AMENDMENTS TO THE DRAWINGS

REMARKS/ARGUMENTS

Fig. 1 Arrangement of System, Picture, Audio and Auxiliary Items in a Content Package on SDTI.
RELATED ART

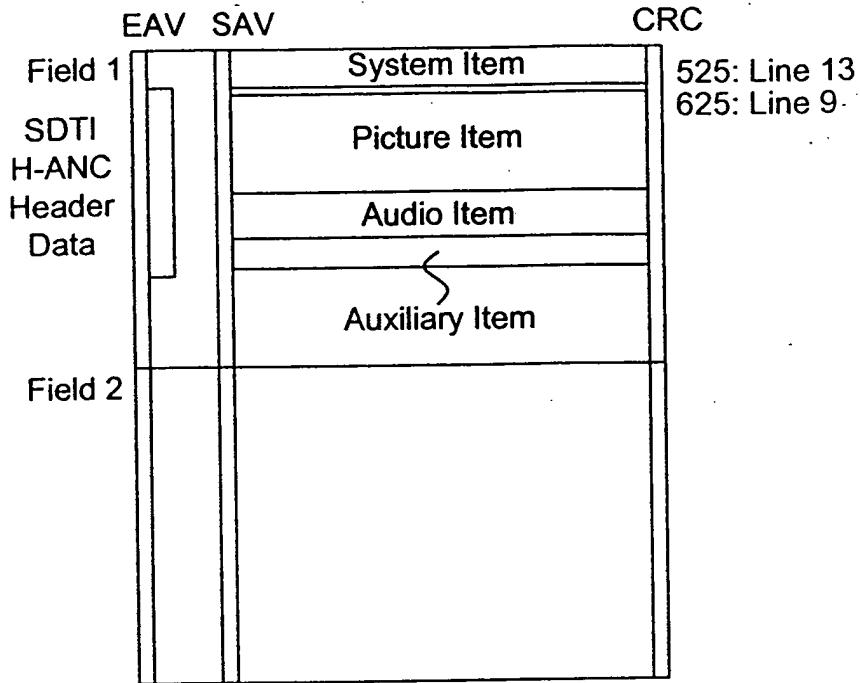
6. In Figures 1-3, the legend "Related Art" has been added.
